**SUBJECT: LIMERICK GENERATING STATION, UNITS 1 AND 2 – STAFF ASSESSMENT
OF RESPONSE TO 10 CFR 50.54(f) INFORMATION REQUEST – FLOOD-
CAUSING MECHANISM REEVALUATION (CAC NOS. MF6107 AND MF6108)**

STAFF ASSESSMENT BY THE OFFICE OF NUCLEAR REACTOR REGULATION

RELATED TO FLOODING HAZARD REEVALUATION REPORT

LIMERICK GENERATING STATION, UNITS 1 AND 2

Figure 3.3-1. Schuylkill River Watershed, Subwatersheds, and USGS Stream Gages Above Limerick Generating Station (Exelon, 2015b)

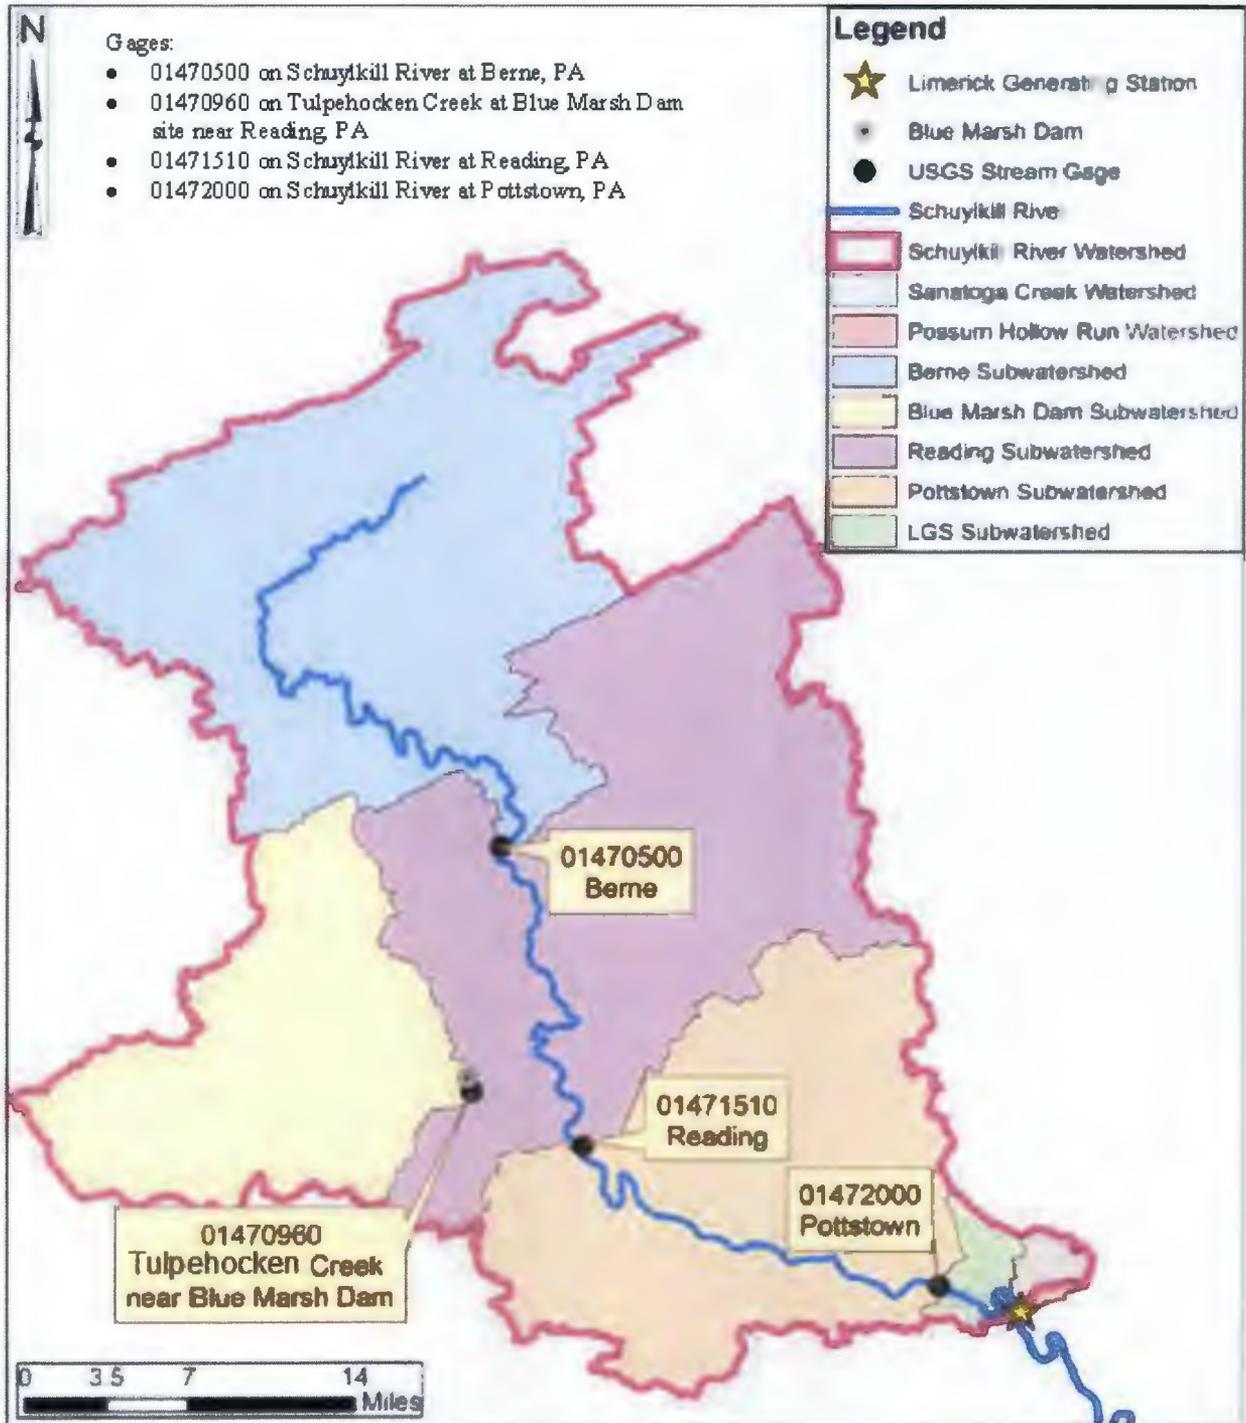
Watershed subdivisions, PMP cumulative temporal distributions, and PMP spatial distributions are shown in Figure 3.2-1, Figure 3.2-2, and Figure 3.2-3, respectively. The licensee concluded that the reevaluated stillwater elevation for flooding from streams and rivers at Possum Hollow Run was bounded by the CDB for the Schuylkill River, but was not bounded by the CDB for Possum Hollow Run (Exelon, 2015a). The licensee also stated that the maximum reevaluated stillwater elevation for Possum Hollow Run (167.8 ft (51.15 m) NGVD29) was lower than both the CDB for flooding from streams and rivers (174 ft (53.0 m) NGVD29 on the Schuylkill River) and the lowest entrance to an SSC (217 ft (66.1 m) NGVD29). There is no stated CDB for Sanatoga Creek; however, the licensee stated that the reevaluated maximum flood stillwater elevation of 153.7 ft (46.85 m) NGVD29 is 20.3 ft (6.19 m) below the CDB flood elevation for the Schuylkill River (Exelon, 2015a).

The NRC staff reviewed the information provided by the licensee regarding the PMF analysis and confirms that the licensee's reevaluation of the hazard from flooding of streams and rivers uses present-day methodologies and regulatory guidance. The NRC staff confirms the licensee's conclusion that the reevaluated hazard for flooding from streams and rivers relative to Schuylkill River and adjacent tributary sources, including Possum Hollow Run and Sanatoga Creek, is bounded by the Schuylkill River CDB flood hazard. Therefore, flooding from streams and rivers does not need to be analyzed in a focused evaluation or a revised integrated.

Figure 3.4-1. Locations of Upstream Dams and the Hypothetical Dam Considered for Dam Failure Analysis (Exelon, 2015b)

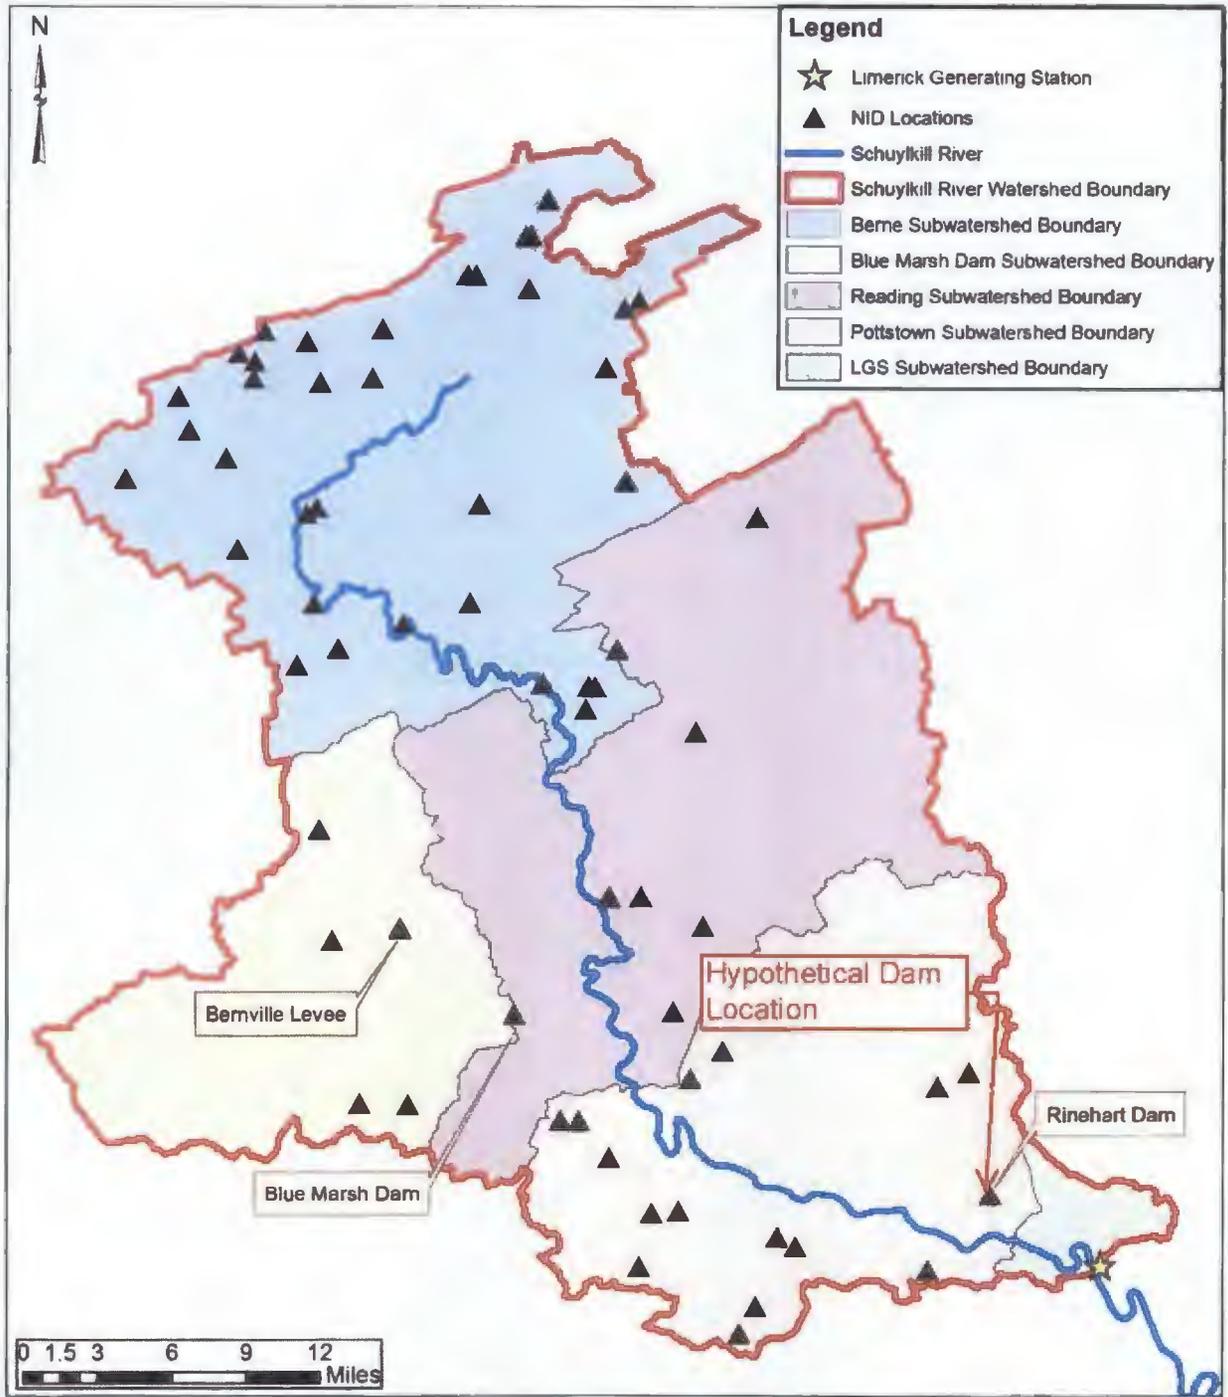
The licensee used the USACE National Inventory of Dams to identify 64 dams upstream of the Limerick site (Exelon, 2015a). These dams are shown in Figure 3.4-1. There are no dams on Possum Hollow Run or Sanatoga Creek. The licensee added the storages of all upstream

reservoirs to obtain the storage of the hypothetical representative reservoir. The licensee estimated the height of the hypothetical representative dam as the average of individual dams' height weighted by the corresponding storages. The estimated height was compared to tallest dams in the Schuylkill River drainage, and the licensee adjusted the height of the hypothetical dam upward (slightly higher than estimated) for conservatism. The hypothetical dam was placed 7.8 mi (12.6 km) upstream of the Limerick site, which is the location of the closest upstream dam. The licensee estimated the peak dam breach outflow from the hypothetical representative dam using the U.S. Bureau of Reclamation attenuation equation, (NRC, 2013b). The licensee estimated that the attenuated dam breach discharge at the Limerick site would be 431,000 cubic feet per second (cfs) (12,205 cubic meters per second). The licensee applied the attenuated dam breach discharge to the Hydrologic Engineering Center – River Analysis Center PMF model at the location of the Limerick site and performed a steady-state simulation to estimate the flood water surface elevation resulting from the breach of the hypothetical representative reservoir coincident with a PMF in the Schuylkill River drainage. The licensee reported that the reevaluated maximum flood stillwater surface elevation at the Limerick site is 192.5 ft (58.67 m) NGVD29, which is 8.5 ft (2.59 m) below the CDB for Schuylkill River dam failure water surface elevation of 201 ft (61.3 m) NGVD29 (Exelon, 2015a).

The licensee evaluated the coincident wind-wave effects using the maximum reevaluated Schuylkill River stillwater elevation of 192.5 ft (58.67 m) NGVD29 resulting from a postulated hydrologic dam failure coincident with a PMF in the drainage area (Exelon, 2015a). The licensee estimated the fastest 2-minute, 2-year wind speed using the NOAA National Climatic Data Center Global Historical Climatology Network (NOAA, 2015b; see Exelon, 2015a). The licensee fit the Gumbel statistical distribution to the observed fastest 2-minute wind data and estimated the 2-year return period wind speed as 39.7 mph. The licensee estimated the straight-line fetch in the critical direction using PAMAP digital elevation data (PADCNR, 2016). The licensee estimated the wave height and period, wave setup, and wave runup using USACE Coastal Engineering Design and Analysis System-Automated Coastal Engineering System computer software (USACE, 1992) distributed by Veritech Enterprises, LLC (Veritech, 2016) and the wind setup using the approach described in USACE Engineering Manual 1110-2-1420 (USACE, 1997). The licensee reported the wind setup, wave setup, and wave runup to be 0.8, 2.3, and 6.6 ft (0.24, 0.70, and 2.01 m), respectively (Exelon, 2015a). Therefore, the licensee stated that the combined events Schuylkill River maximum flood water surface elevation is 202.2 ft (61.63 m) NGVD29, which is 4.8 ft (1.46 m) below the CDB combined events water surface elevation of 207 ft (63.1 m) NGVD29. The licensee concluded that the reevaluated hazard for failure of dams and onsite water control or storage structures was bounded by the CDB (Exelon, 2015a).

The NRC staff reviewed the flooding hazard from failure of dams and onsite water control or storage structures against the relevant regulatory criteria based on present-day methodologies and regulatory guidance and confirms the licensee's conclusion that the reevaluated flood hazard for failure of dams and onsite water control or storage structures is bounded by the CDB flood hazard. Therefore, flooding from this hazard does not need to be analyzed in a focused evaluation or a revised integrated assessment.
